Engineering Handbook

SURFACE EQUIPMENT (EHB-8)

MODIFICATION INDEX - CLOUD MEASURING EQUIPMENT

CLOUD HEIGHT MEASUREMENT EQUIPMENT MODIFICATION NO. 21
(For Electronics Technicians)

U.S. DEPARTMENT OF COMMERCE
NATIONAL OCEANIC & ATMOSPHERIC ADMINISTRATION
NATIONAL WEATHER SERVICE
1A13W DARD C
WIND SPEED/GUST
SCHEMATIC
DATE: 6-9-78
DRAWING NO.: B701-DR022
SCALE: NONE
SHEET 1 OF 2

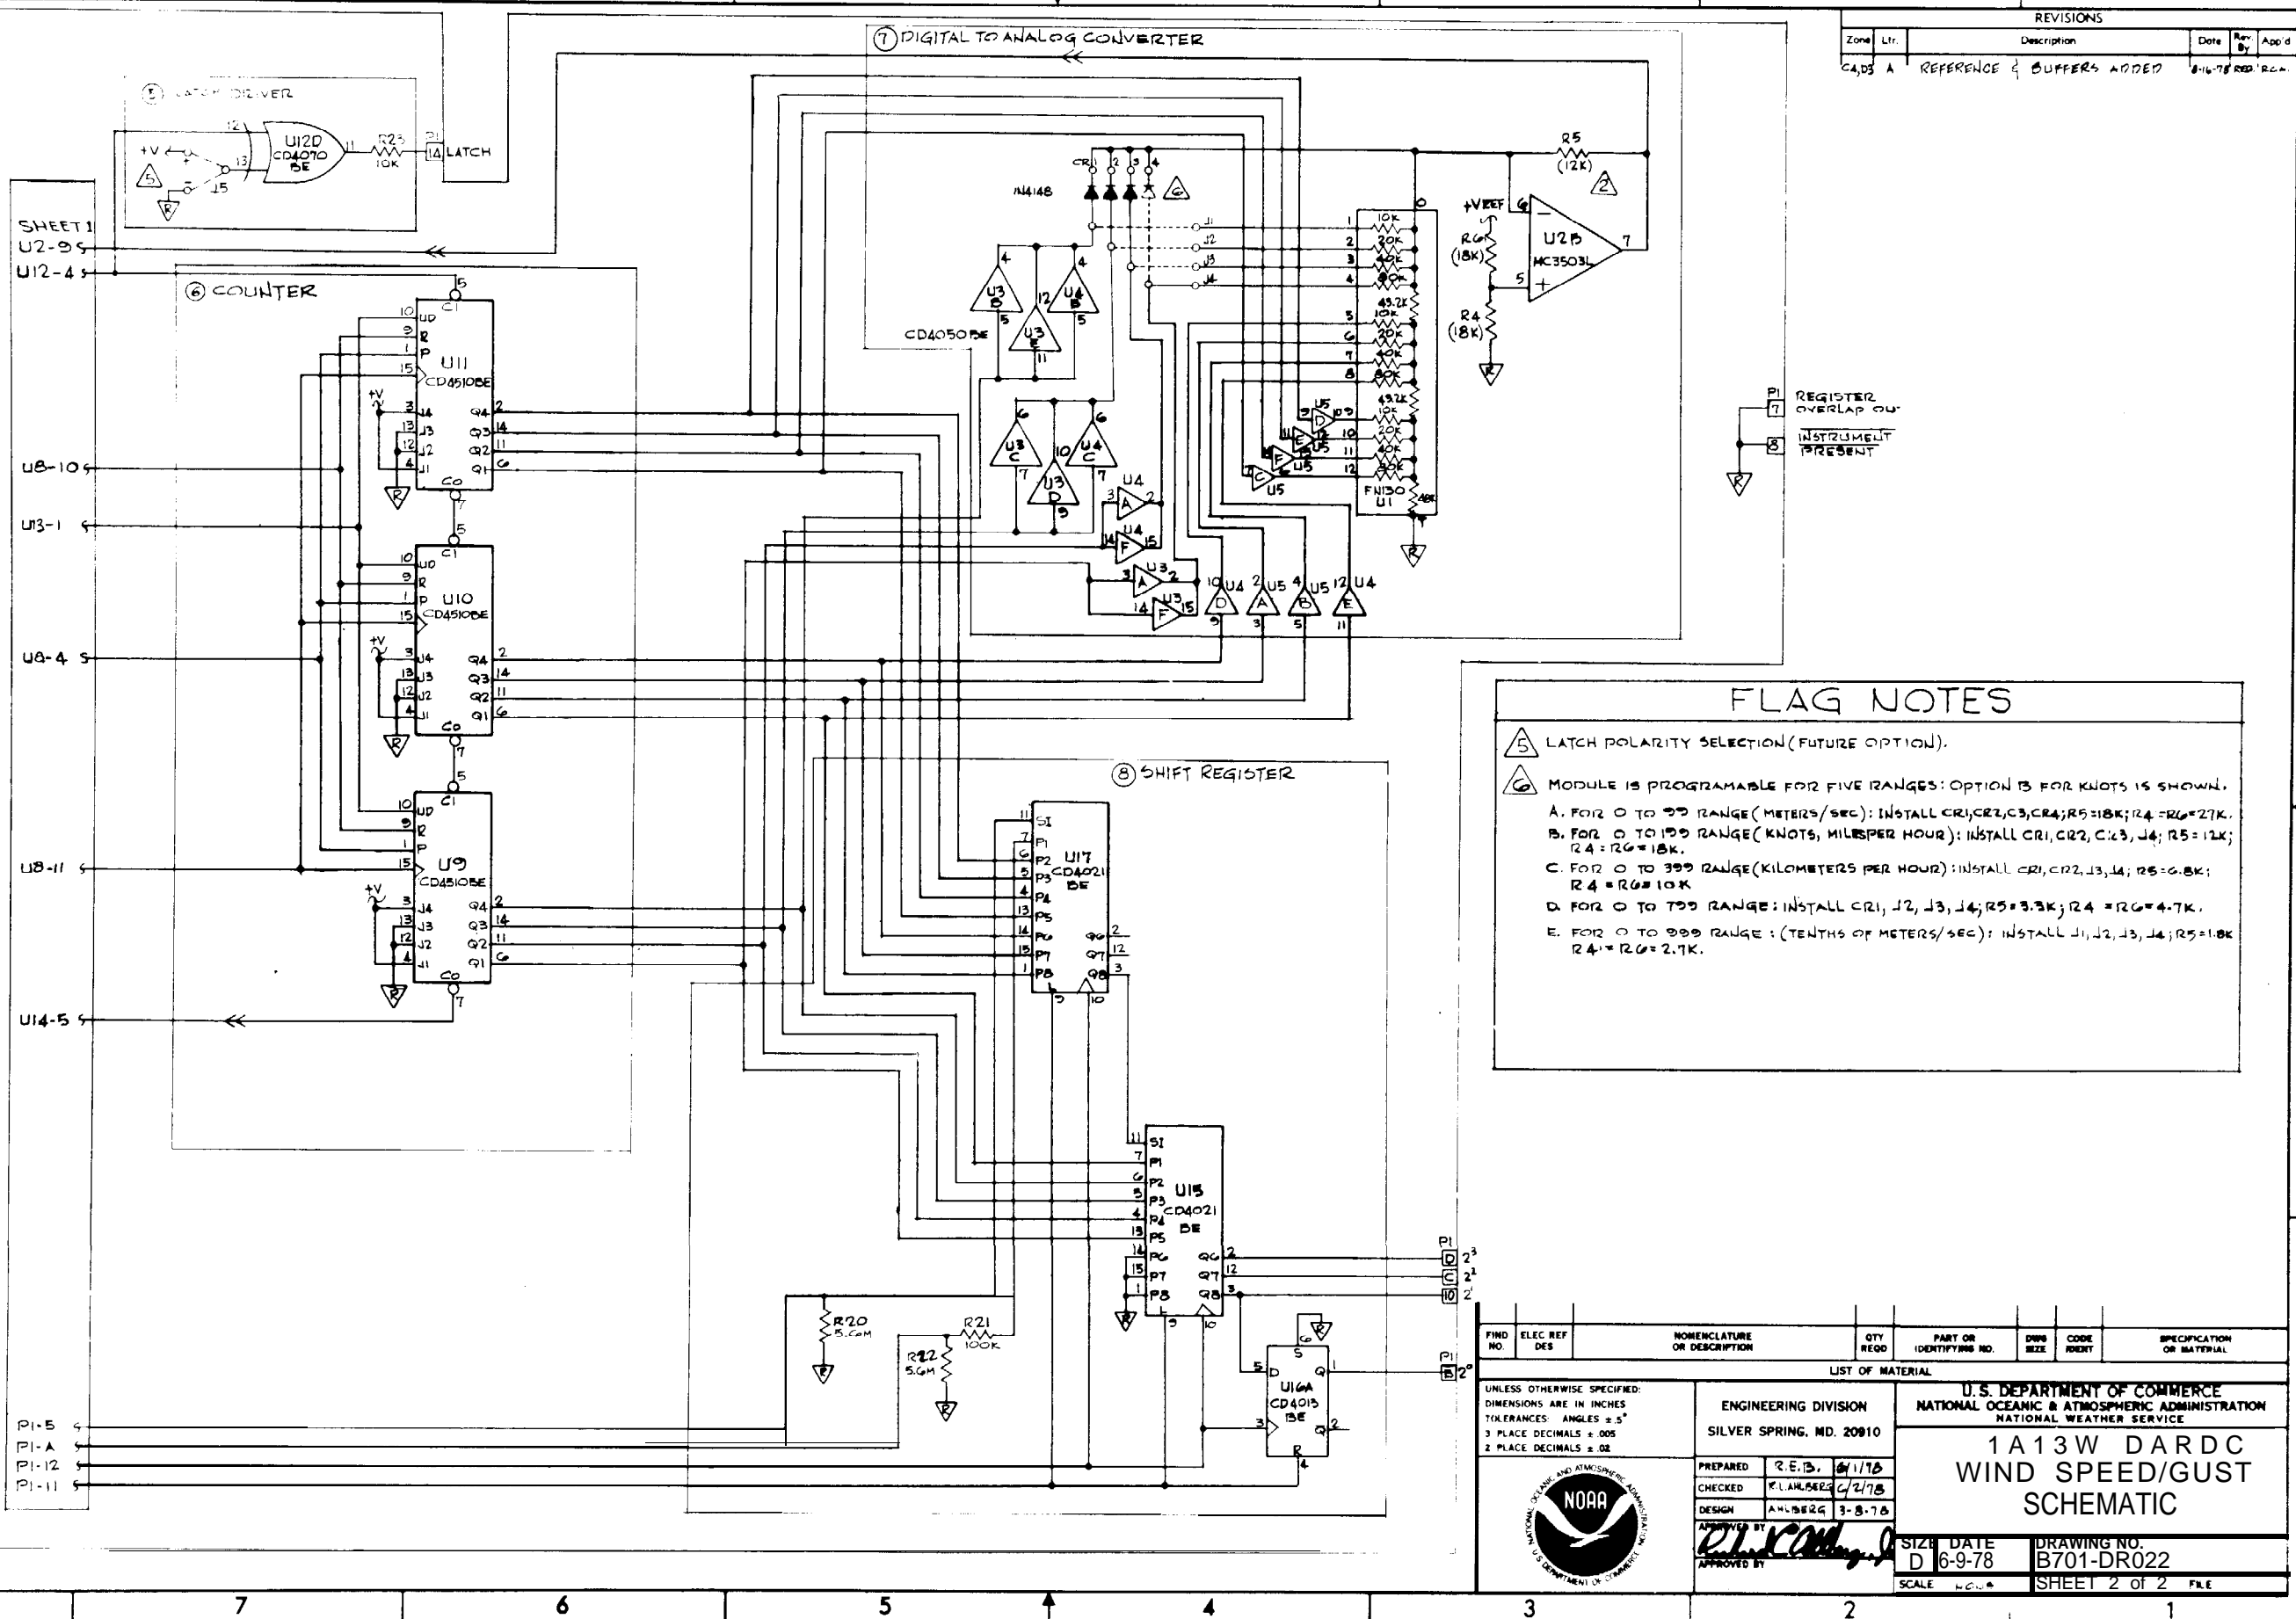
Wind Speed/Gust Drawing No. B701-DR0022, Sheet 1 of 2 was
erroneously omitted in Wind Modification No. 3. Insert the
attached drawing with the original modification note.

FIGURE 1

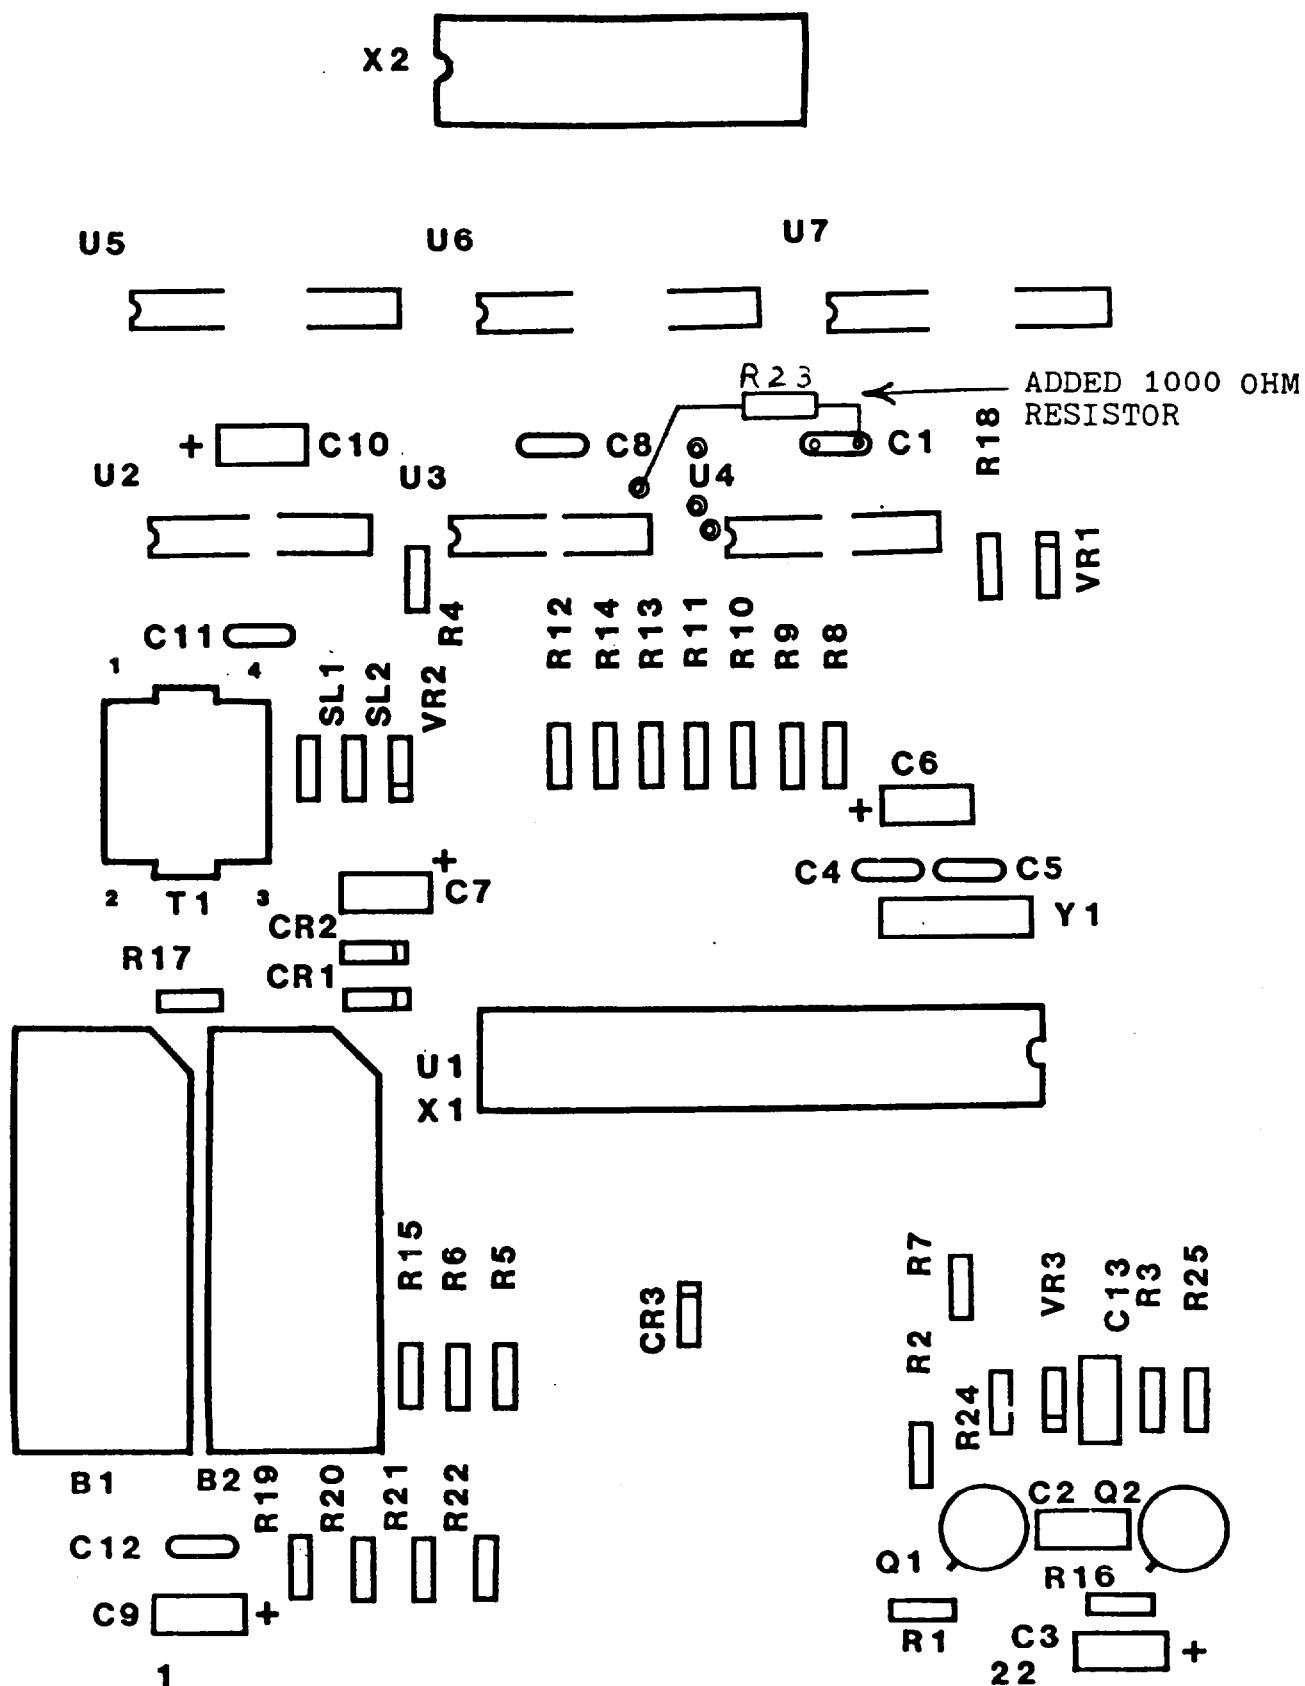
25. Turn the display unit so that the rear panel is facing you. Remove the receive logic PC board, with the ribbon cable still attached, and place it in position to install R23, 1000 ohm resistor, as shown in Figure 1. Install R23.

FIGURE 1

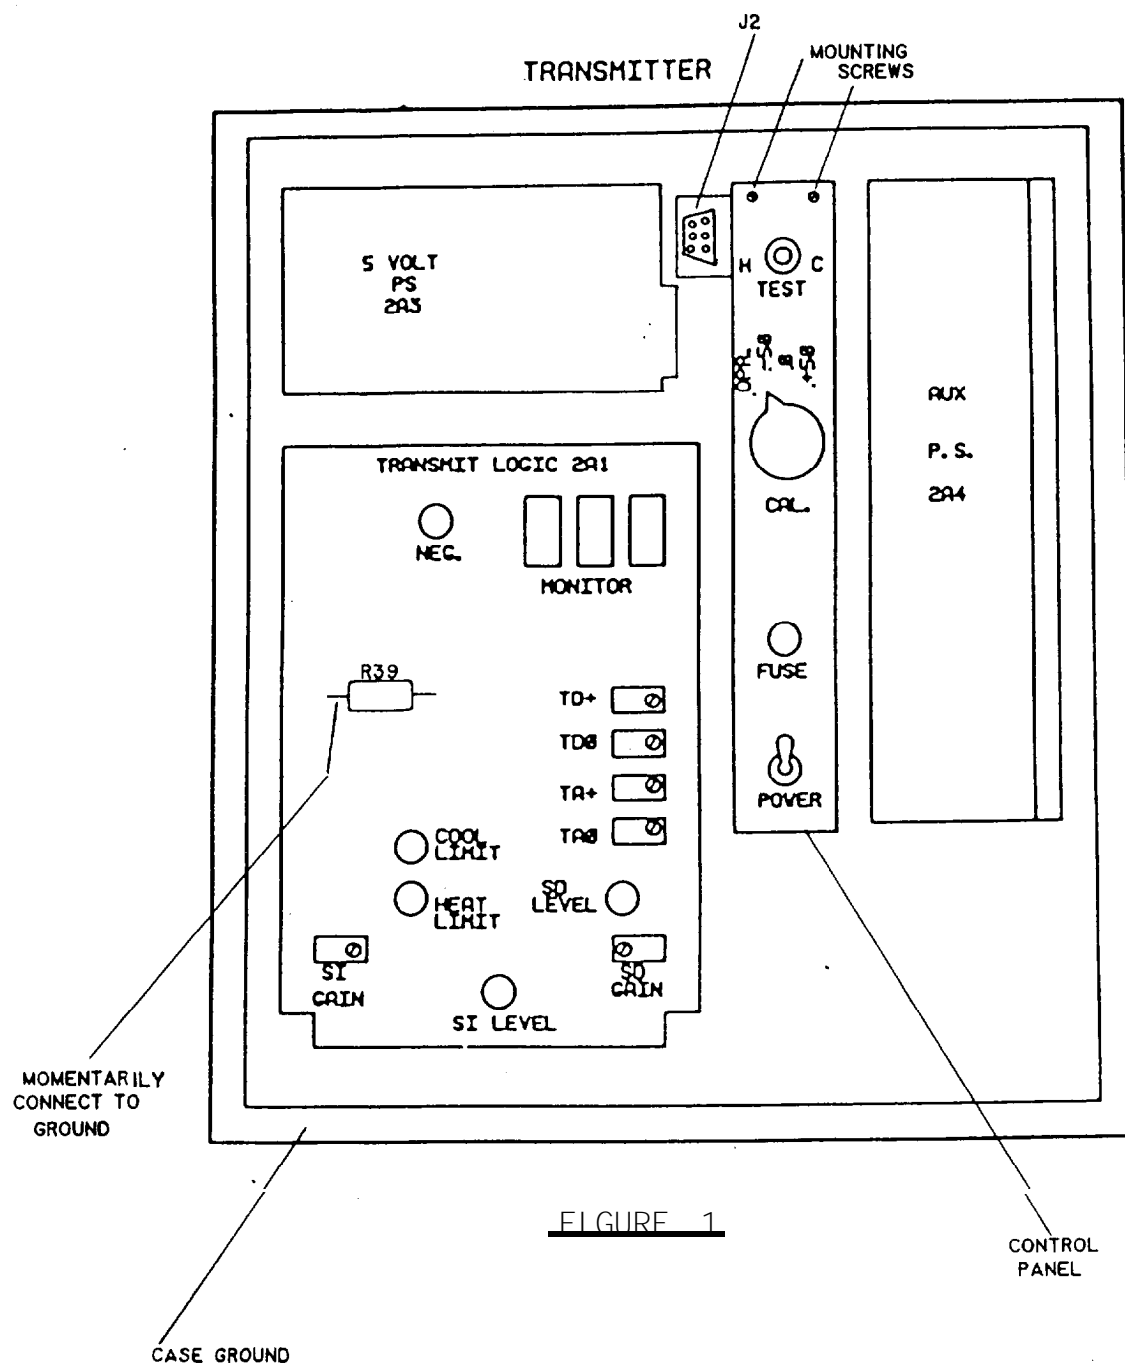
1. Open transmitter door and switch power off.
2. Remove two screws at the upper end of the transmitter control panel (see Figure 1).
3. Carefully install the Autobalance Module, as illustrated in Figure 2. Plug Autobalance Cable into 52, and secure plug with the locking hardware provided.
4. Manually turn the Autobalance Dial ccw to 000.

COMPONENT SIDE OF TRANSMIT LOGIC BOARD

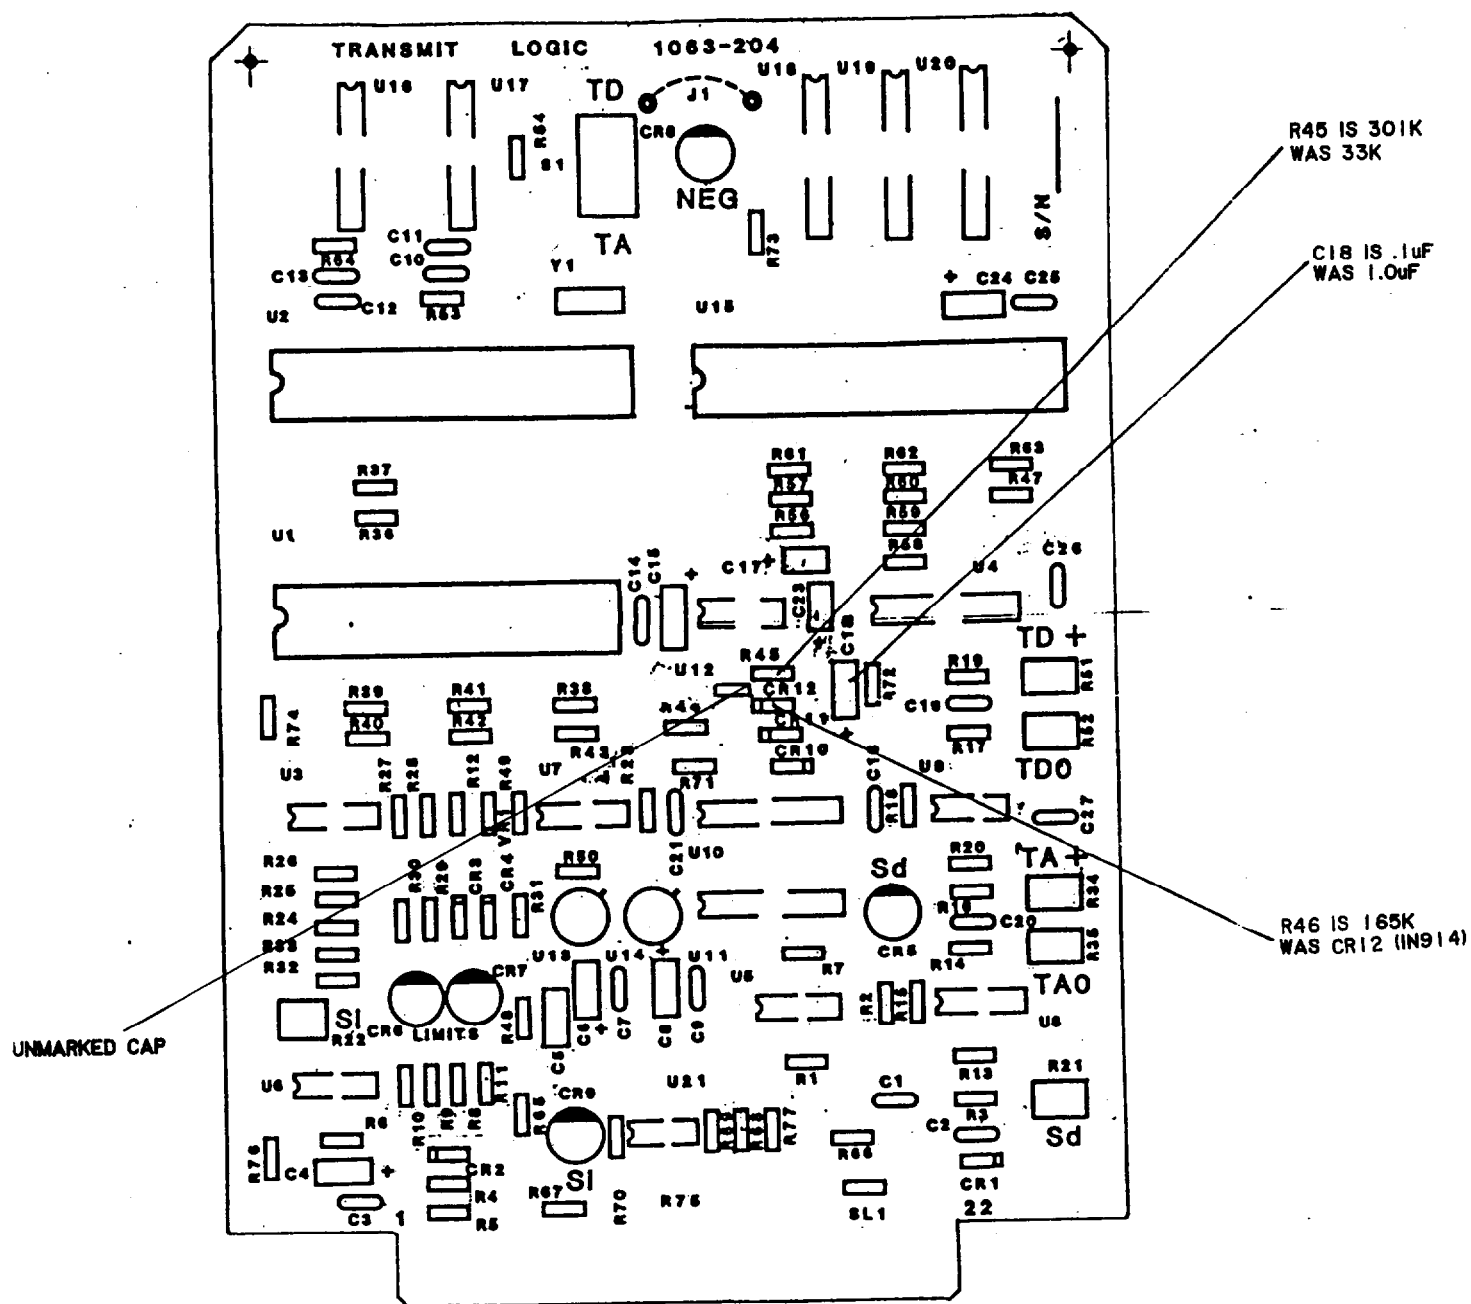
1. Remove the transmitter logic board from the spares kit and unsolder and remove R45, C18, and CR12. See Figure 1.
2. Position transmit logic board with component side up on work bench and locate an unidentified capacitor, located between R45 and CR12. Turn board over and locate the leads to this capacitor. Between these leads will be found a land that will have to be cut and separated. See Figure 2. Cut and separate the land.

3. Mount, solder, and trim R45, the 301K resistor. See Figure 1.
4. Mount and solder R46 (165K) in the CR12 position. Bend and position the lead of R46 from the cut land to ground. Use insulating sleeving over this lead of R46. Trim sleeving over the ground and solder and trim lead to ground. See Figure 2.
5. Trim the other side of R46.
6. Mount, solder, and trim C18, the .1 UF capacitor. See Figure 1.
7. Exchange the modified spare transmit logic board with the field site logic board and verify operational system functions.
8. If modified spare board is working properly in system, return to shop with unmodified transmit logic board. Modify field transmit logic board per steps 2 through 7.
9. Place modified transmit logic board in spares kit.
